SUPPLEMENTARY MACHINE SERVICE BULLETIN No. 108-A

SUBJECT: Plus, Minus and Shift Key Locks-
KAE and KASC Models.

DATE: July 16, 1931

FIG. 1.

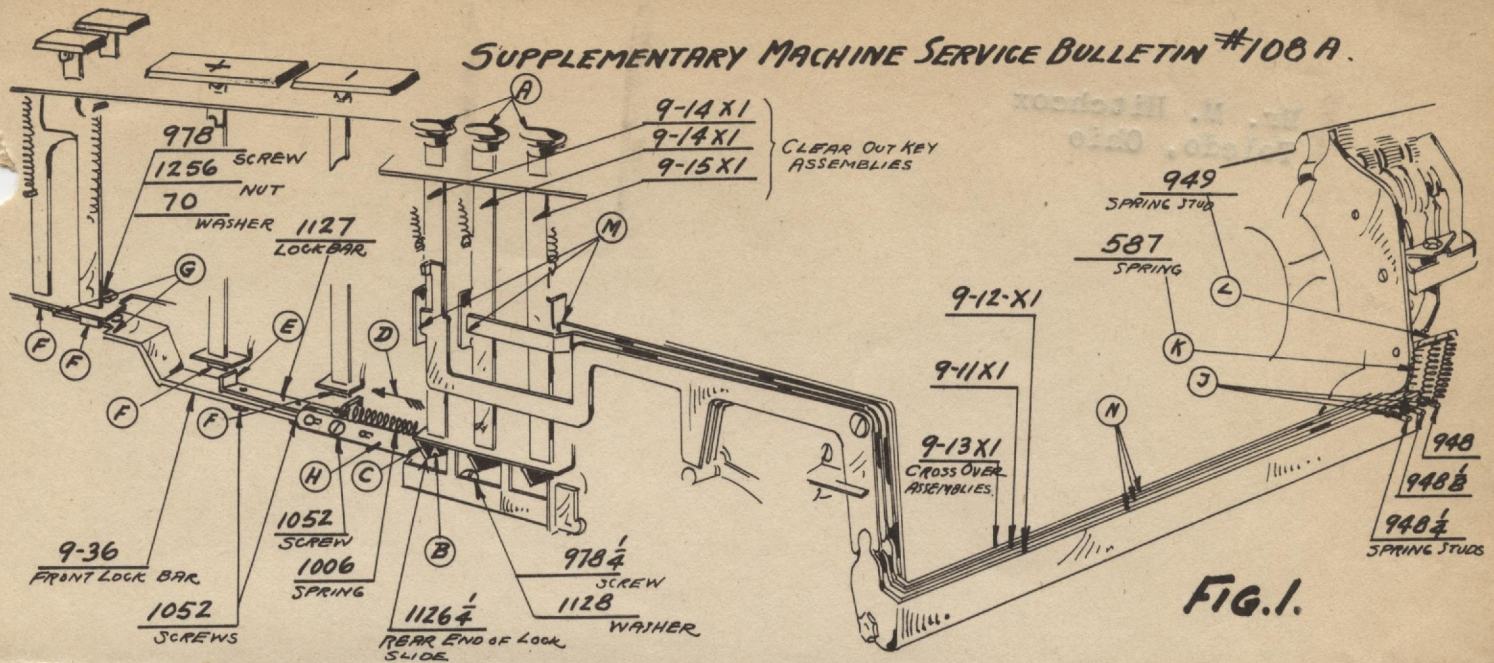
We now have in production a new style locking device for the purpose of locking the plus, minus and shift keys against depression while the dial clearing keys mechanism is functioning. This is now standard equipment in all machines being manufactured of these models.

ABOVE IS SHOWN THE FUNCTIONING OF THE LOCKING DEVICE FOR THE PLUS AND MINUS AND SHIFT KEYS-DEPRESSION OF ANY KEY (A) FORCES END (B) AGAINST INCLINED SURFACE (C) THUS FORCING LEVER (H) REARWARD IN DIRECTION OF ARROW (D) - THIS LEVER (H) CONTAINS TWO BLANKS (E) AND (G) WHICH CONTAIN SURFACES THAT SERVE TO LOCK THE KEYS (F) BY CONTACT AGAINST DEPRESSION.

NOTE - CROSS OVER LEVERS (N) HAVE BEEN PROVIDED WITH 3 SPRING POSTS (J) THESE POSTS HOLD 3 SPRINGS (K) TO PIN (L) IN THE GEAR CASE - THIS RESULTS IN A MORE POSITIVE CONTROL OF THE NOSES IN RELATION TO THE PAWLS IN THE DRUMS.

NOTE - ADDING THE SPRINGS (K) AND THE CLOSING OF SLOTS (M) IN KEYS (A) HAS ELIMINATED THE NECESSITY OF LOCKS (BB) SHOWN ON PLATE 22 BULLETIN #108

Remove bracket 9-28, locate drill jig #1 on it and drill clearance hole for 978 screw with #28 drill.

Remove lock bar 1527, guide blank, 1526, and start and stop switch. Scrap lock bar 1527.

Locate drill jig #2 on pin post 1051 on the 9-10 assembly, drill hole with #32 drill and tap with 6/40 thread.

Tilt machine upward and drill a hole in guide blank 1525 with #50 drill for spring 1006, or remove blank 1525 and drill the hole.

This mechanism can now be assembled and adjusted as illustrated and explained in figures #1 and #2 of this bulletin.

FIG. 2

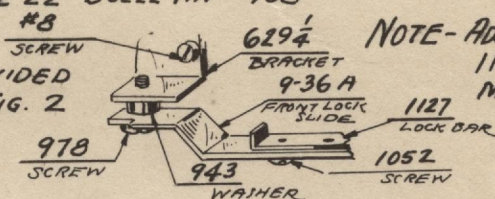
NOTE - ADJUSTING SCREWS 1052 IN LOCK BARS 1126 1/4 - 1127 - ARE PROVIDED SO THAT THIS MECHANISM MAY BE ADJUSTED TO SUIT.

FIG. 3

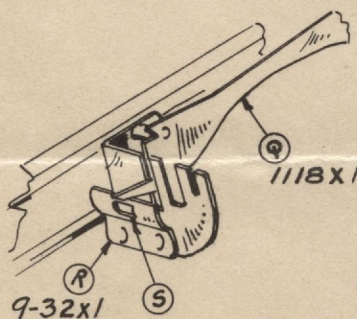
Figure 3 of this bulletin illustrates and describes a change in design that was made to overcome the possibility of the carriage shifting the wrong way when the right-hand shift key is operated.

THE ABOVE CHANGES IN DESIGN HAVE BEEN MADE TO OVERCOME THE DIFFICULTY EXPERIENCED ON ACCOUNT OF THE CARRIAGE SHIFTING THE WRONG WAY WHEN THE RIGHT-HAND SHIFT KEY IS DEPRECATED. (FIG. 3.)

THE CHANGE IN BLANK (Q) AND THE ADDITION OF PART (R) HOLD THE ENGAGEMENT OF BLANK (Q) WITH PIN #968 IN FRONT SHUTTER SHIFT BAR #9-19 ASSEMBLY (FIG. 3A)

THE SLOT (S) IN BLANK (R) IS PROVIDED SO THAT BLANK (Q) CAN PERFORM ITS NORMAL FUNCTION WHEN THE LEFT HAND SHIFT KEY IS DEPRECATED

This mechanism can be incorporated, where required in KASC models, in the field as it is only necessary to remove rivet #1076 (not shown) and blank #1118 on the 9-23 assembly, and replace it with blank #1118xl, and to replace the 9-32 assembly with 9-32xl, shown as (R).

FIG. 3A

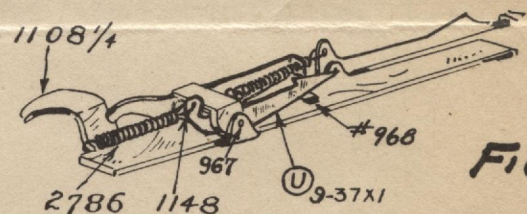
THE ADDITION OF LATCH (U) - 9-37x1 ASSEMBLED AS SHOWN TO #949 ASSEMBLY CAUSES AN ENGAGEMENT BETWEEN IT AND #9-32x1 WHICH PREVENTS THE CARRIAGE FROM SHIFTING TO THE RIGHT IN AUTOMATIC DIVISION.

Figure 3A - Latch U, 9-37xl, can be assembled to the 9-19 assembly by removing pivot pin 967 and omitting spacer 1148, and attaching its tension spring 2786 to blank 1108 $\frac{1}{2}$ on the 9-19 assembly as shown. The addition of this latch (U) causes an engagement between it and the 9-32xl which prevents the carriage from shifting to the right in automatic division.
